AGENDA
BOARD OF PUBLIC WORKS MEETING
Tuesday, September 29, 2020 at 7:00 p.m.
Jackson Village Hall
N168 W20733 Main Street
Jackson, WI 53037

**SECTION 00941
CHANGE ORDER**

Change Order No. 2

Date of Issuance:	August 31, 2020	Effective Date:	August 31, 2020
Owner:	Village of Jackson	Owner's Contract No.:	A-20
Contractor:	Wondra Construction, Inc.	Contractor's Project No.:	
Engineer:	Cedar Corporation	Engineer's Project No.:	05789-0008
Project:	Spruce Street and Ridgeway Drive Extensions	Contract Name:

STANDARD CONCRETE DRIVEWAY APPROACH & SIDEWALK

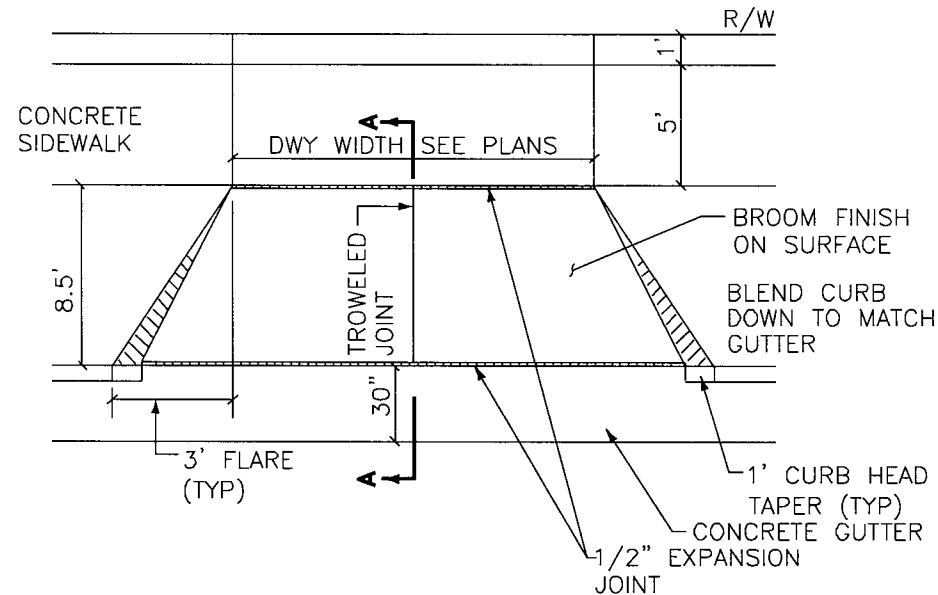
- c) Change Order Item No. 3: Owner elected to add a driveway apron on Spruce Street at Ridgeway Drive extended for the purpose of providing access to the adjacent agricultural land.

As discussed at yesterday's progress meeting, the Owner has decided to add a driveway approach within the south curb line of Spruce St at Ridgeway Dr. extended. The proposed approach is 25' wide (excluding flares) and includes a 7" concrete approach and sidewalk. Attached please find revised plan sheet 5 of 27 which includes the proposed approach plus, a second sheet which includes a detail for a Standard Concrete Driveway Approach & Sidewalk.

I met with the Owner this morning to discuss your submitted unit price of \$7.60 per lineal foot related to the addition of a 7" concrete driveway approach and sidewalk on Spruce Street. As a result, the Owner finds your submitted unit price to be reasonable and therefore, has been approved by the Owner.

VILLAGE OF JACKSON
SPRUCE STREET AND RIDGEWAY DRIVE EXTENSIONS
WASHINGTON COUNTY, WISCONSIN
SPRUCE STREET PLAN AND PROFILE

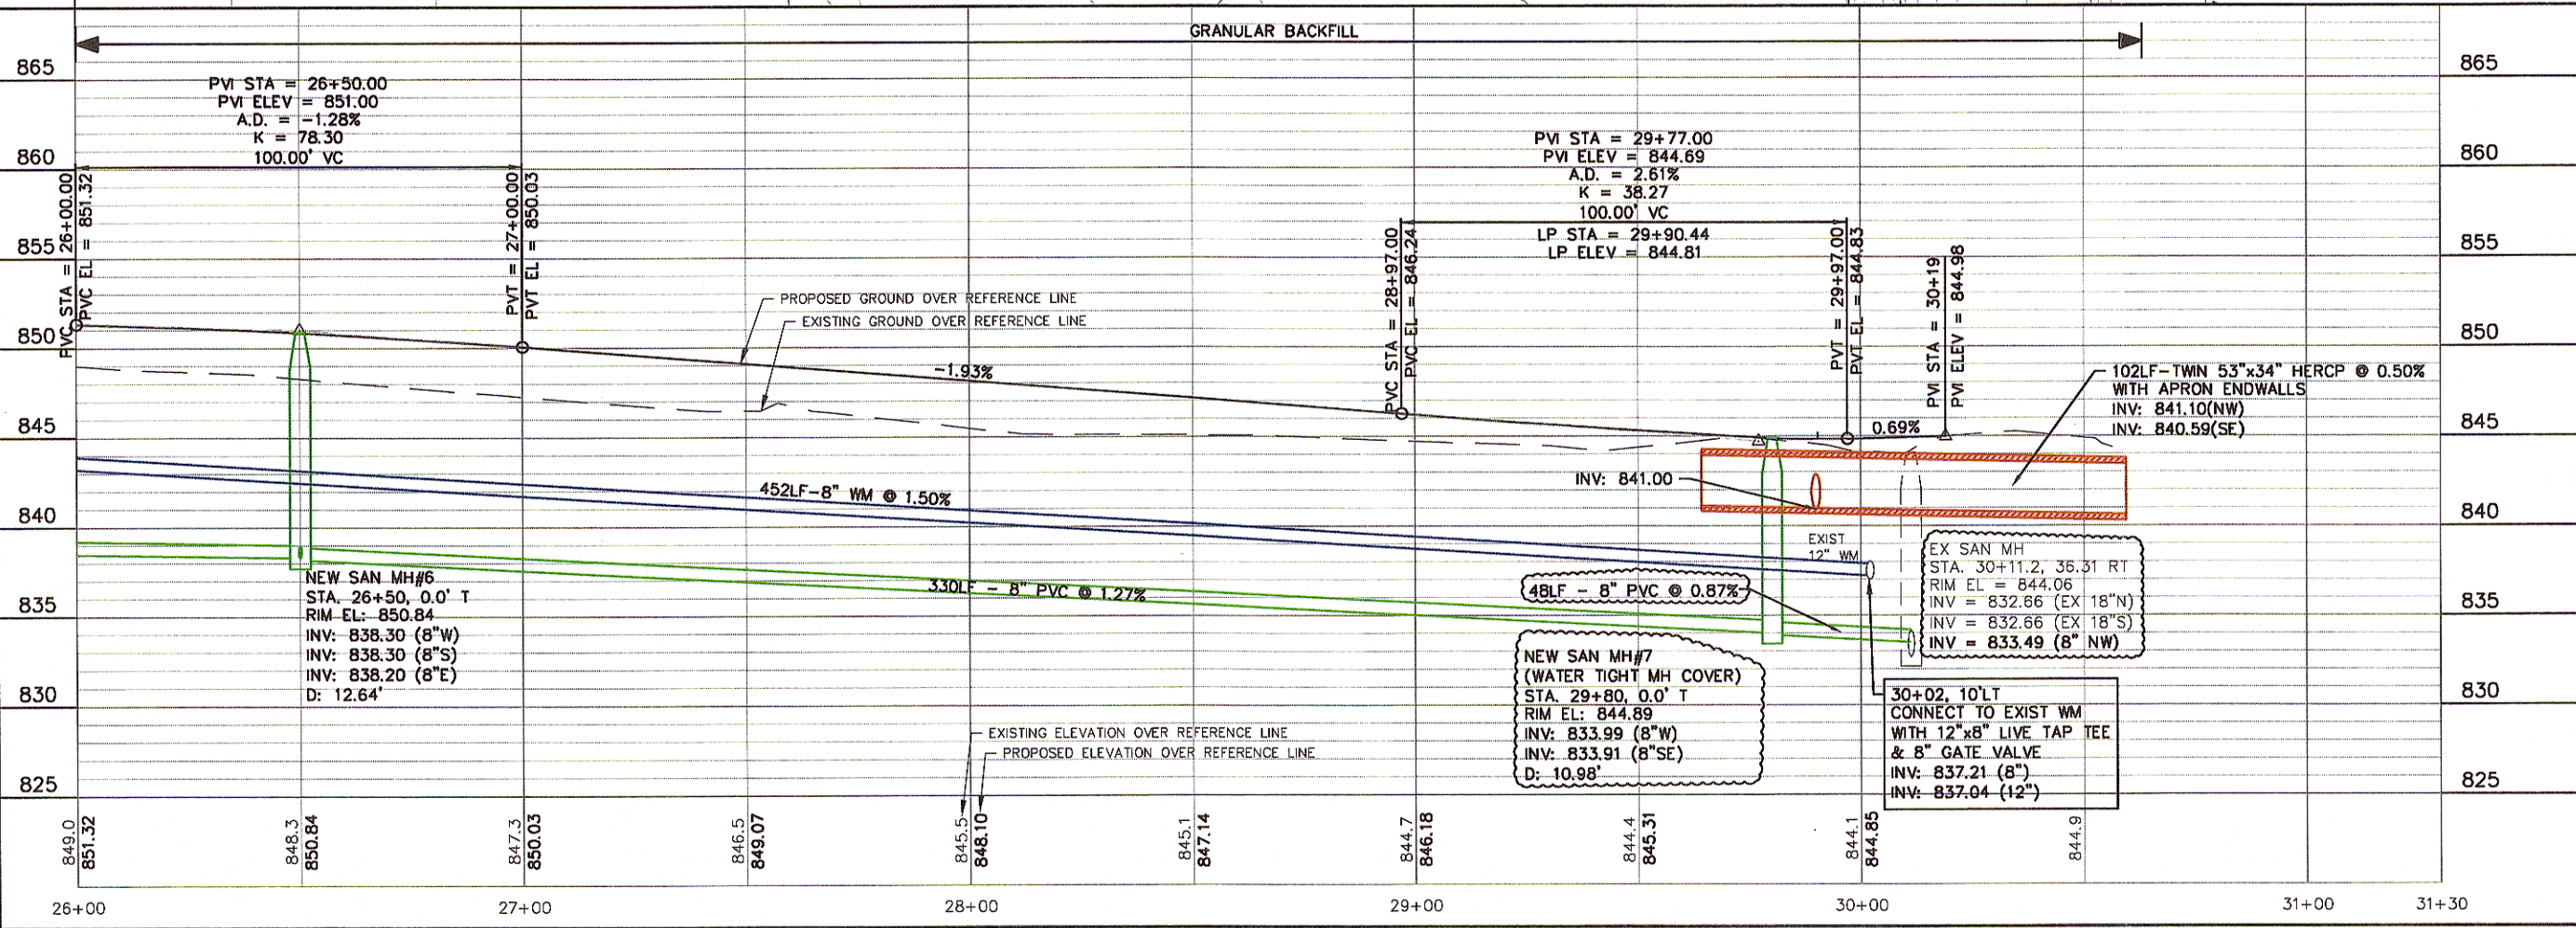
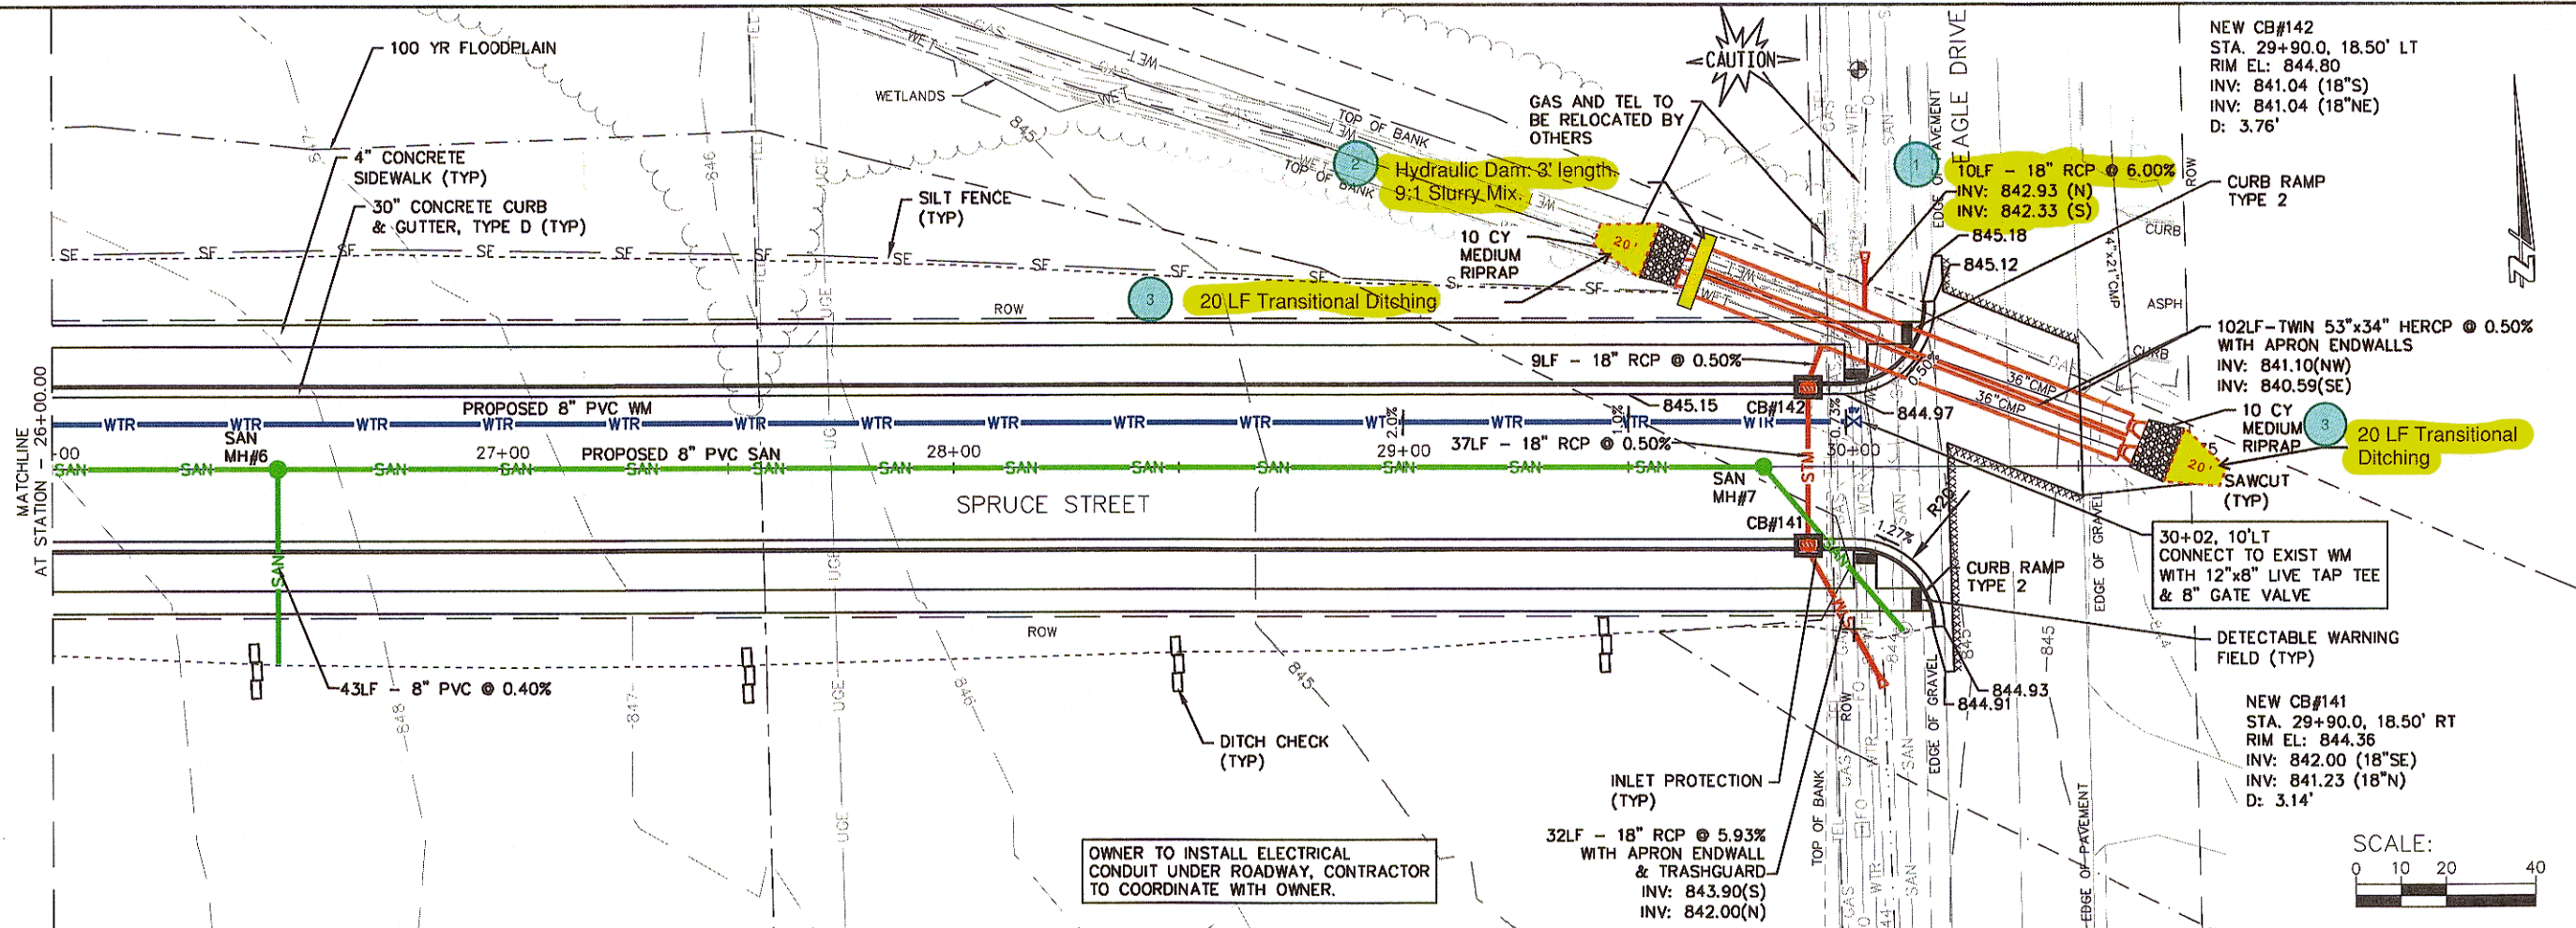
- f) Change Order Item Nos. 6, 9 & 10: Additional storm sewer pipe installed within the west ditchline of Eagle Drive north of the newly installed cross culverts. Additional storm sewer pipe installed to capture south flowing stormwater to the cross culvert location.

- g) Change Order Item No. 7: Owner directed Contractor to install a hydraulic dam at the inlet ends of the two Eagle Drive cross culverts for the purpose of preventing the migration of water from around the culvert pipes.

- h) Change Order Item No. 8: Width of newly installed cross culverts on Eagle Drive were wider than the existing stream banks requiring transition grading from the width of the two culverts to the width of the existing stream banks.

"The Owner of the subject project is requesting price quotes for the following items associated with the Eagle culvert installations as illustrated below and within the attached plan sheet:

Install 18" RCP culvert to accept existing ditch flow on the north side of cross culverts. Work to include 10 LF of 18" RCP, Apron End Wall, Connection to Existing Culvert, Backfill and Lawn Restoration. Provide pricing as follows:

Install 3' hydraulic dam at the east end of culverts using 9:1 Slurry Mix encompassing entire width of trench, pipe bedding up to top of pipe. Provide pricing as follows:

Perform transitional grading from end of rip rap areas transitioning 20' to the contours of existing creek banks and flow line east & west. Work to include: excavation, grading, topsoil, seeding and erosion mat within side slopes. Provide pricing as follows:

- The cost of \$1,100 each appears reasonable under the circumstance that the dam installation required specific effort related to re-excavating and backfilling for the sole purpose of installing the dam.
- In the case of the dam installed around the water main, the dam was installed at the time of the water main connection. Under this condition, the cost of the dam would be primarily reduced to the cost of the dam material: Approx. one cubic yard of slurry mix. **Revised price of \$400 for the dam around the water main.**

Based upon the above information, we ask that your revisit your pricing related to the water main dam and resubmit."
